UNITED STATES PATENT AND TRADEMARK OFFICE

APPLICATION NO.	FILING DATE	FIRST NAMED INVENTOR	ATTORNEY DOCKET NO.	CONFIRMATION NO.
09/863,181	05/23/2001	William A. Cox	CWL-101-A	9646

Office Action Summary

REF. AS

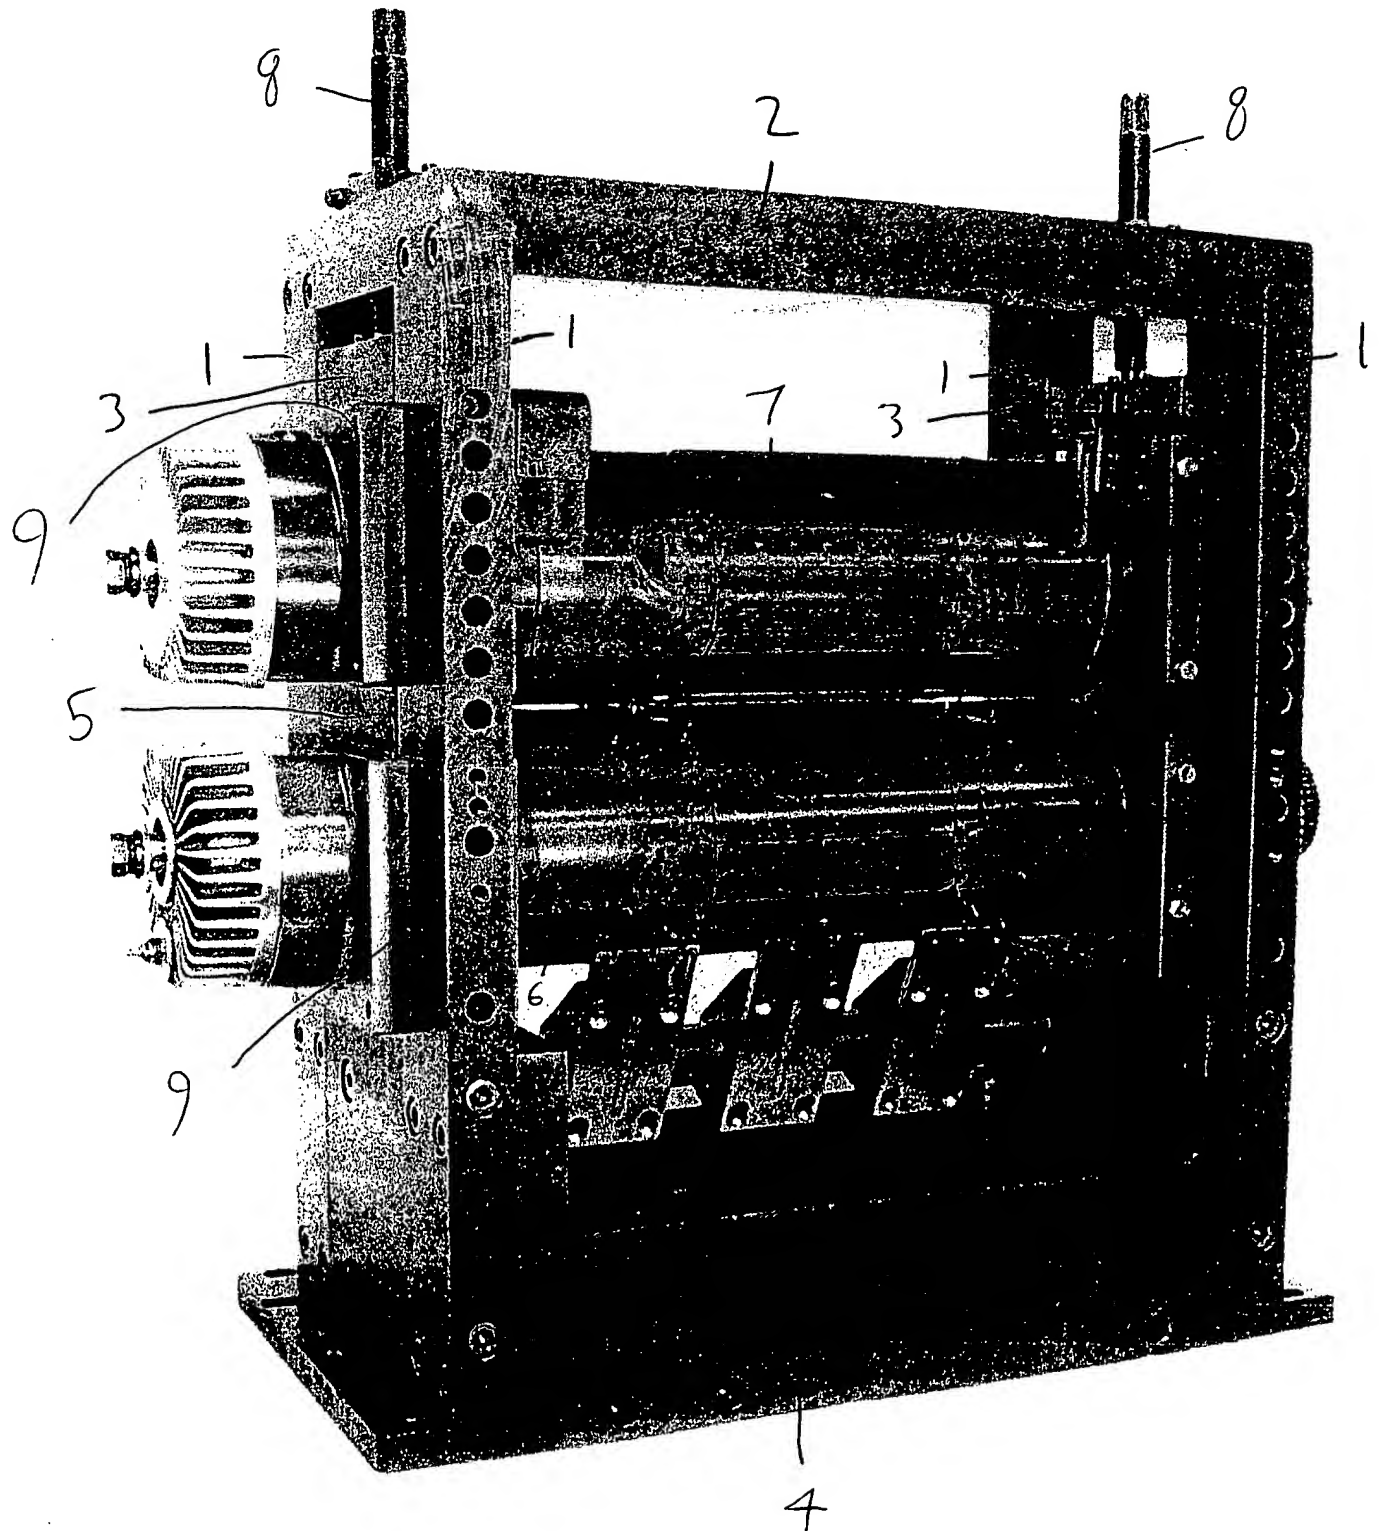
2. Claims 1,3-11,13-17,36 and 40 are rejected under 35 U.S.C. 103(a) as being unpatentable over the Bernal rotary die module (reference AS from the 23 May 01 I.D.S.) in view of Bell et al. '247.

The Bernal rotary die module show has four detachable columns (1), one cover (2), two cross members (3), a base (4), a spacer (5), a lower rotary die (6), and an upper rotary die (7). Both dies have journals encased in bearing blocks (9) and have raised flanges. Bernal also shows a pressure member (8).

Bernal's cross members must have some sort of die support on them, but it is not clearly shown. Bernal's base must have some sort of die support thereon, but it also is not clearly shown. However, Bernal industries also has the patent to Bell, who shows that it is well known for the cross members to have an upper die support in the form of two circumferentially spaced rotary bearings (114), and for the base to have a lower die support (106) having rotary bearings (108). It would have been obvious to one of ordinary skill in the art to have modified Bernal's rotary die by having the cross members have an upper die support in the form of two circumferentially spaced rotary bearings, as taught by Bell, and for the base to have a lower die support having rotary bearings, as taught by Bell, in order to engage and frictionlessly press the rotary dies together. The lower die support could also be modified to have circumferentially spaced

rotary bearings, as taught by the top die support, in order to more accurately support the die.
